# ITEM OF CONCERN (I.O.C)

Project Name: Lodi Memorial Hospital – South Wing Addition

PCD Project No: 07-137

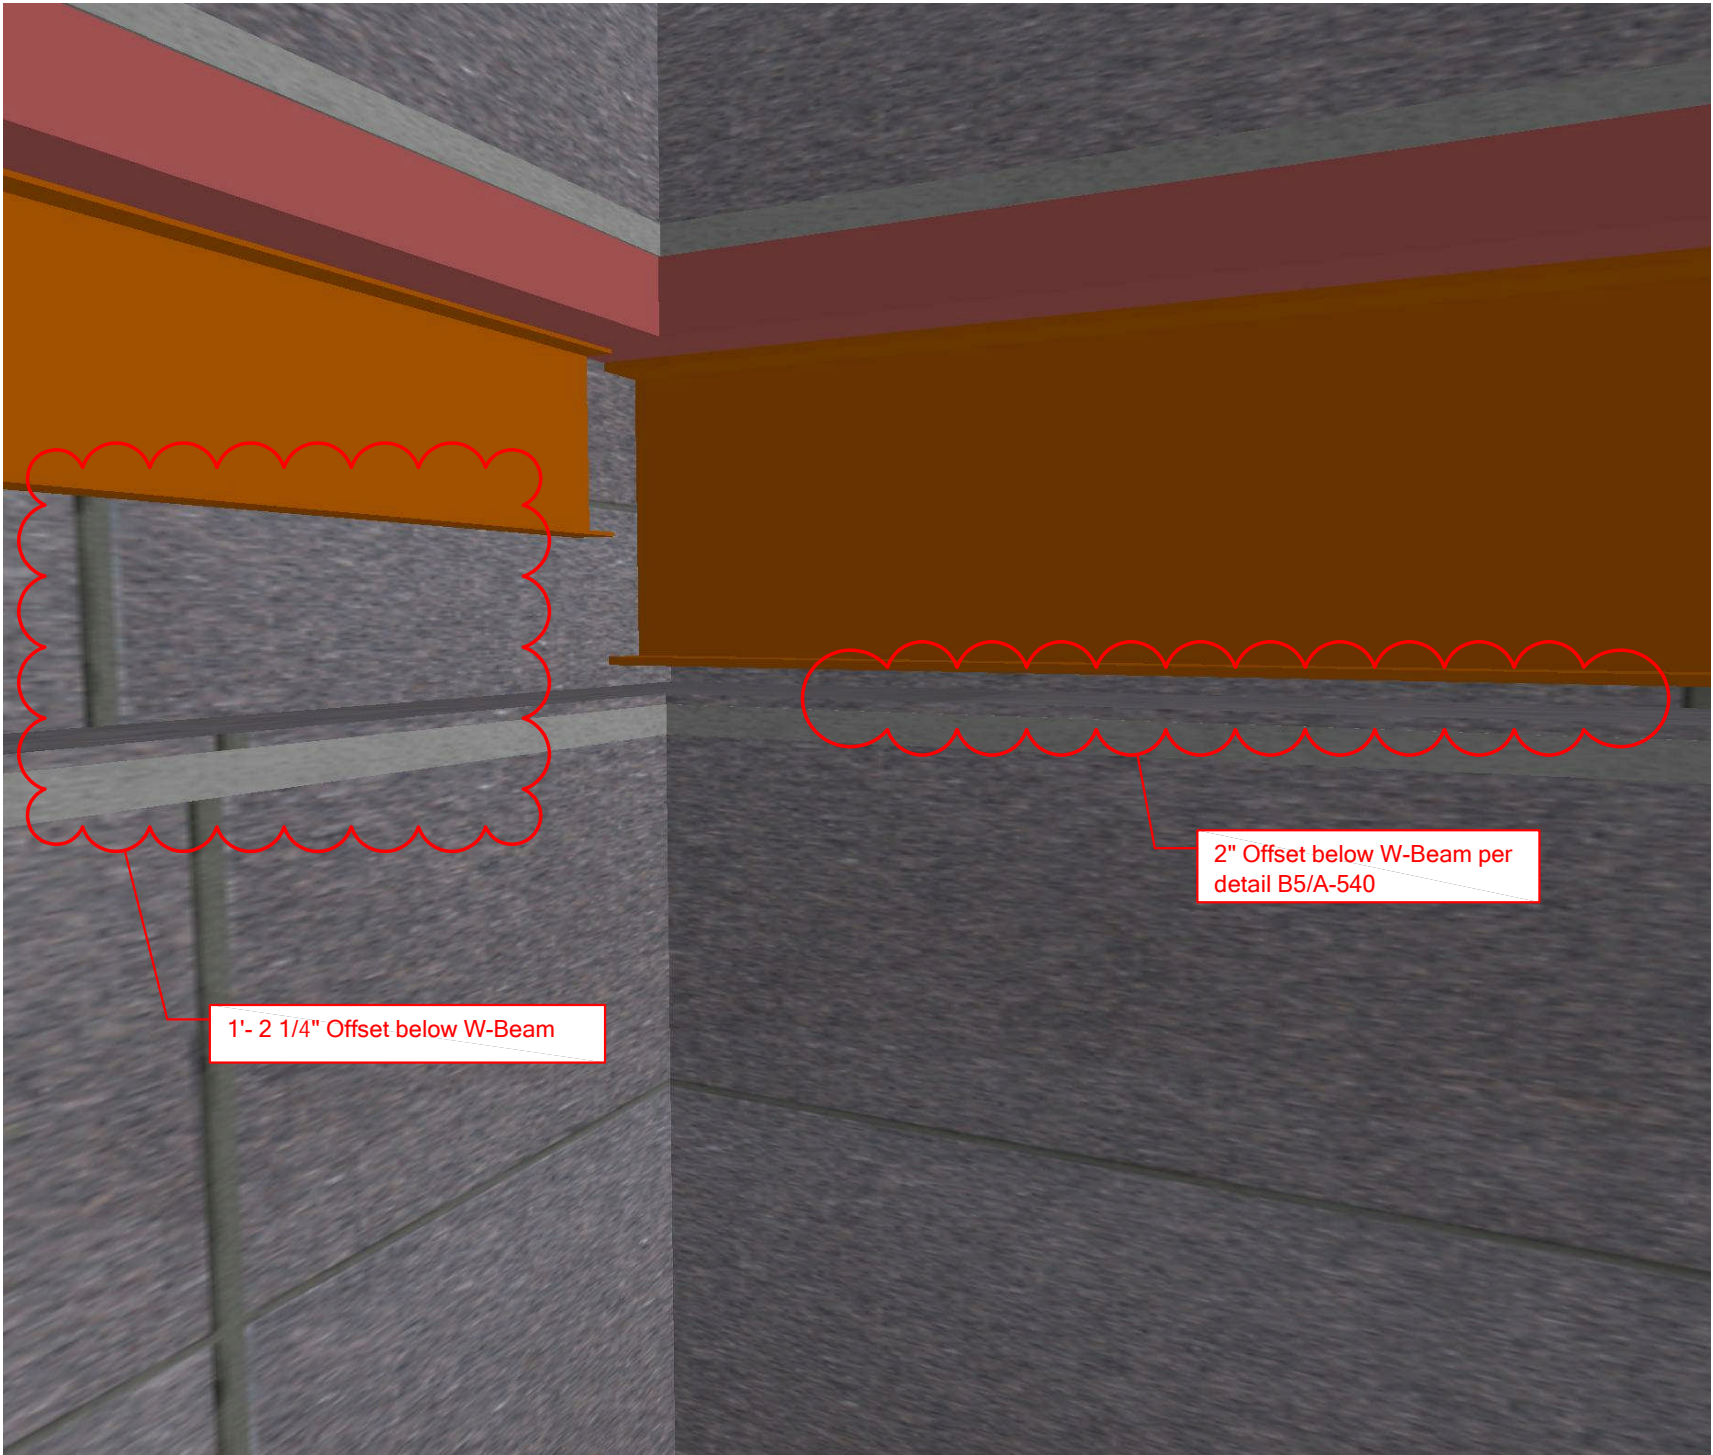
1'- 2 1/4" Offset below W-Beam

2" Offset below W-Beam per detail B5/A-540

**Information Request:** Detail B5 states that at locations where shaft wall is required to wrap around beam, for shaft wall to offset 2" below beam at Z-Clip. However, there is no detail provided stating how this applies when there are varying beam heights located at a single offset. Please provide additional information and details that shows how to join walls with different offset heights to ensure 2HR fire-rating is maintained.

DRAWN BY		CHECKED BY		SHEET NUMBER	
JMP		RM		AC121	
SCALE: 1/2"		DATE: 9/19/07		REV: --	
DRAWING #		10C-005		JOB # 07-137	
PROJECT: Lodi Memorial, SWA		LOCATION: Lodi, CA		ARCHITECT: HDR	
CONTRACTOR: PCI		MECH, ENG.:

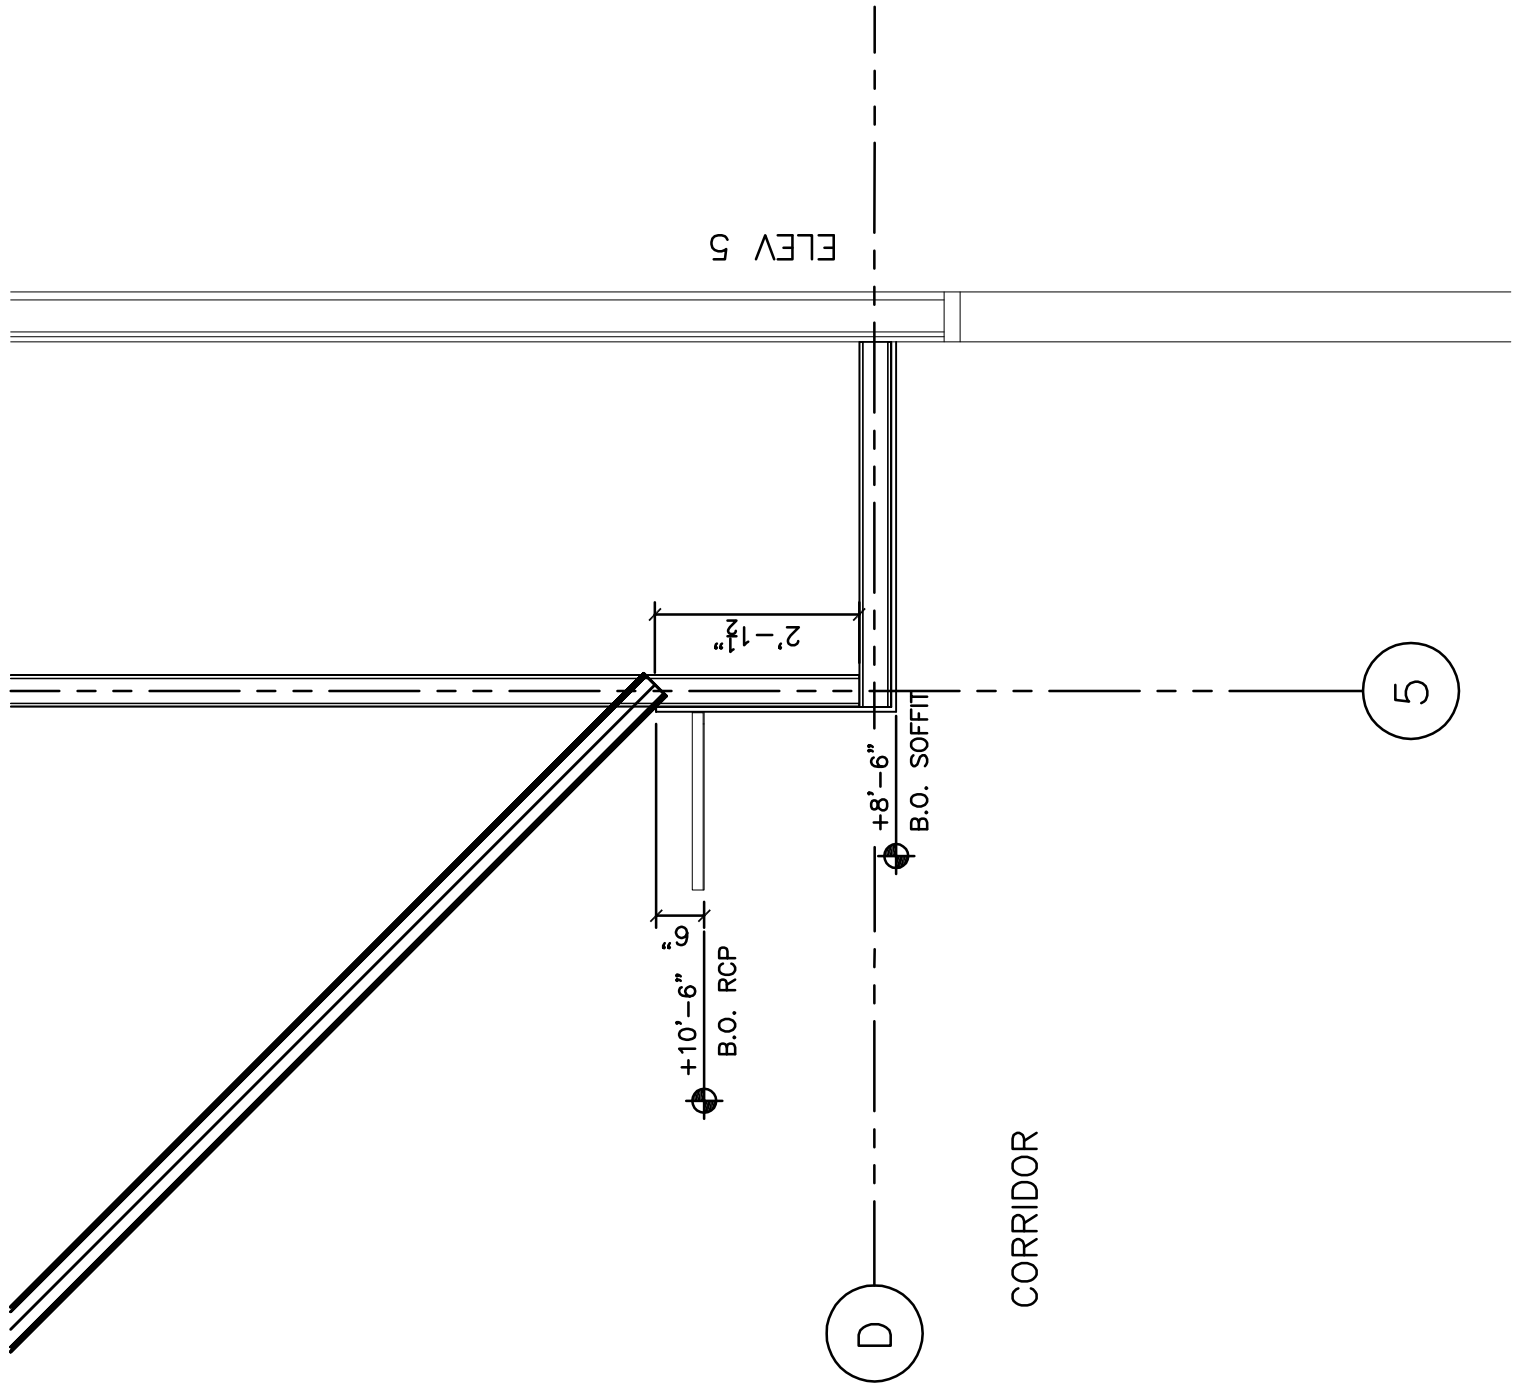
**Information Request:** Details do not specify the maximum distance, from bottom of soffit stud framing, that the bracing can be attached. See attached detail sheet for example. Please confirm maximum height from bottom of framing and advise.
